**PROJECT:** North Hancock Road Extension Phase IIIA and IIIB  
**LAKE COUNTY PROJECT NO.:** 2014-11  
**FPN:** 435515-1-58-01  
**CONTRACTOR:** Pospiech Contracting, Inc.  
**SUBJECT:** School Update Meeting  
**DATE:** September 23, 2015  
**FILE:** 2.3 (09-24-2015\_School\_Update\_Meeting)  
**START:** 10:00 AM **END:** 10:45 AM

**NAME OF PROJECT:** North Hancock Road Extension Phase IIIA and IIIB  
**FINANCIAL PROJECT ID:** 435515-1-58-01  
**LAKE COUNTY PROJECT NUMBER:** 2014-11  
**NAME OF CONTRACTOR:** Posploch Contracting, Inc.  
**SUBJECT:** RFP-12  
**DATE:** September 29, 2015  
**FILE NO.:** 6.2 (09-29-2015\_RFP-12)

**NAME OF PROJECT:** North Hancock Road Extension Phase IIIA and IIIB  
**FINANCIAL PROJECT ID:** 435515-1-58-01  
**LAKE COUNTY PROJECT NUMBER:** 2014-11  
**NAME OF CONTRACTOR:** Pospiech Contracting, Inc.  
**SUBJECT:** RFP-13  
**DATE:** October 2, 2015  
**FILE NO.:** 6.2 (10-02-2015\_RFP-13)

RFP-13; DELETED ITEMS DETAIL

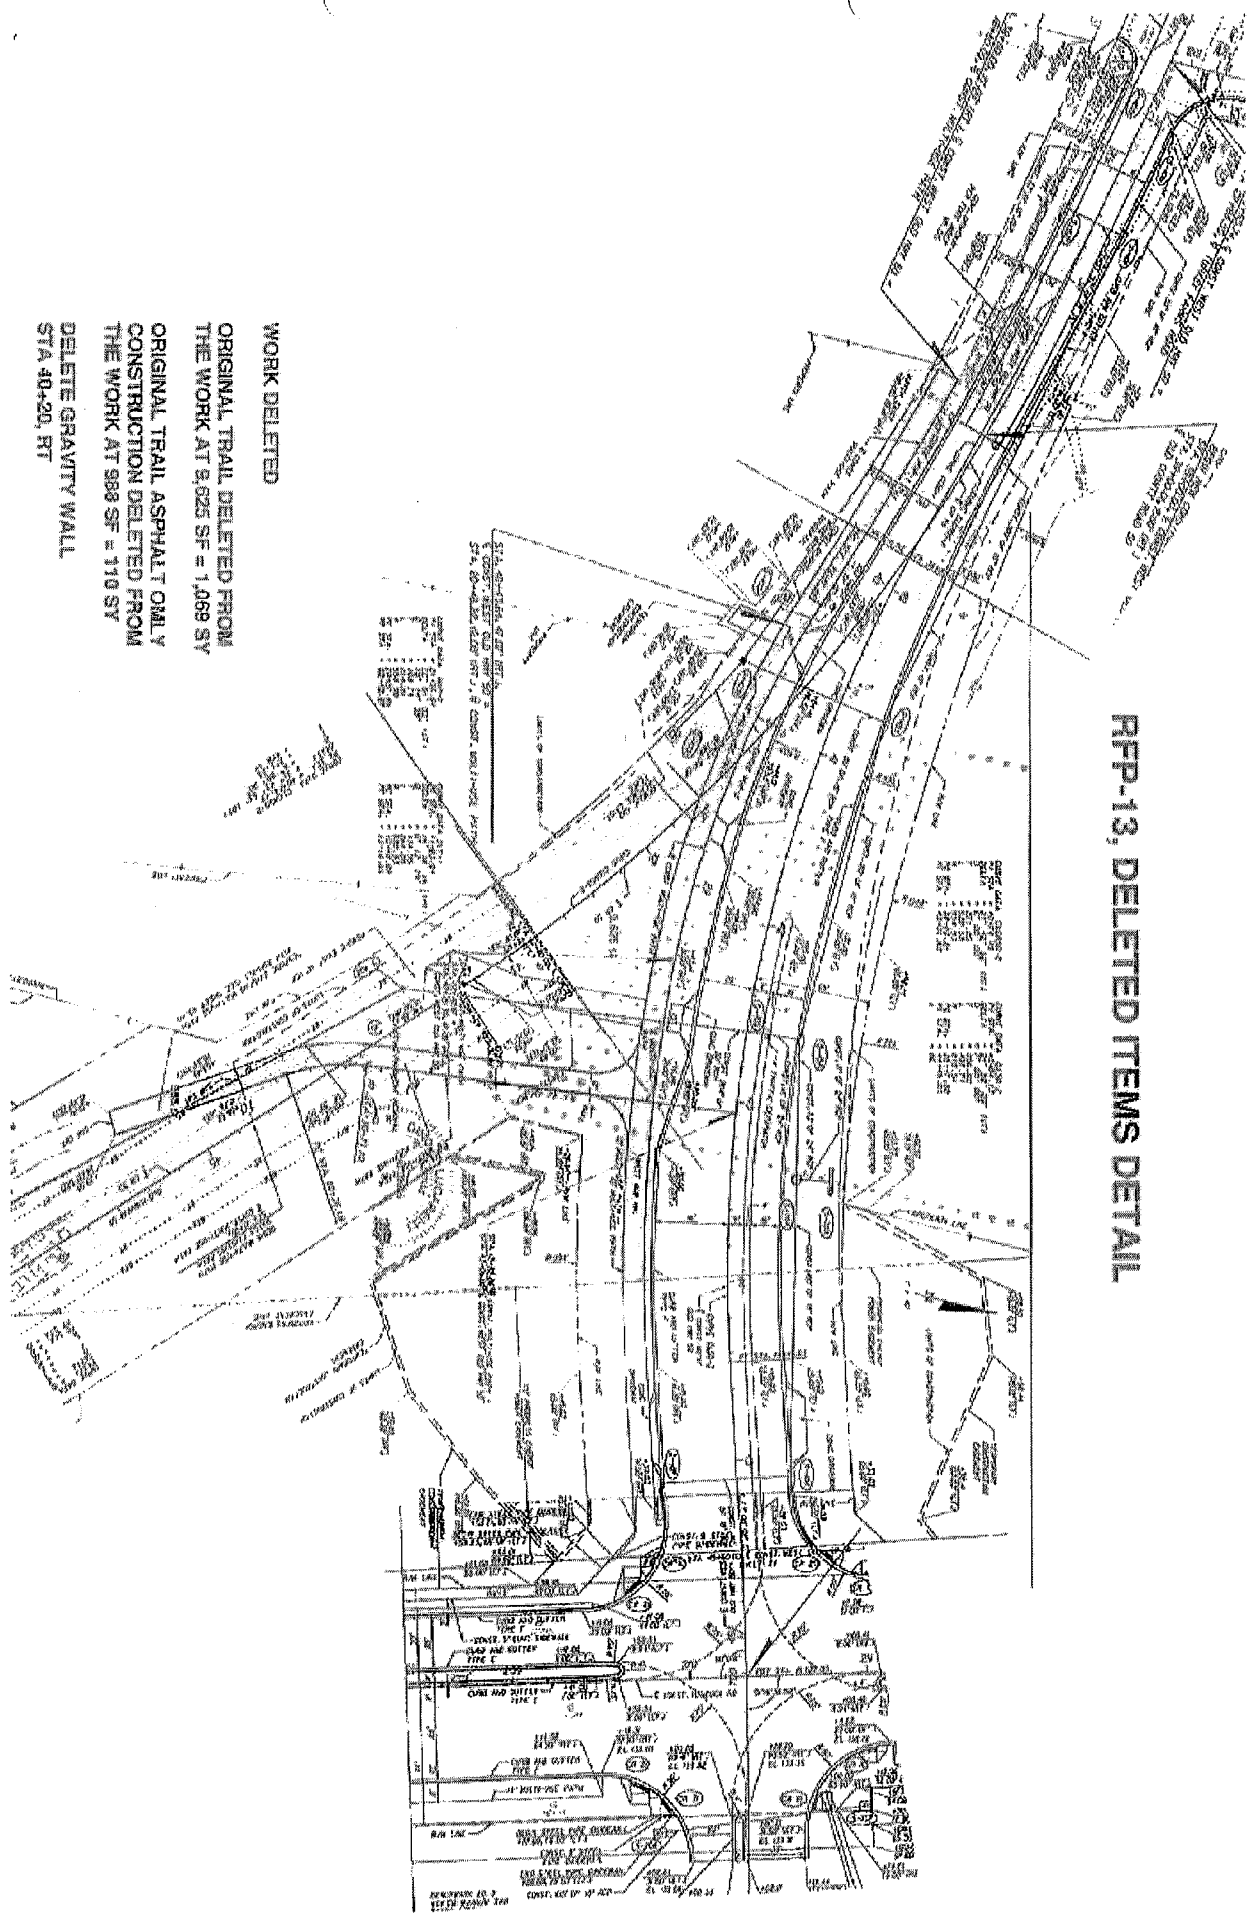
TEMPORARY ADDED WORK DETOUR 2A

TEMPORARY PAVEMENT AT

1140 SF = 127 SY

BARRELS AT 10' SPACING AT 60

WORK DELETED  
ORIGINAL TRAIL ASPHALT ONLY  
CONSTRUCTION DELETED FROM  
THE WORK AT 988 SF = 110 SY  
DELETE GRAVITY WALL  
STA 40+20, RT

WORK DELETED  
ORIGINAL TRAIL DELETED FROM  
THE WORK AT 6,625 SF = 1,409 SY
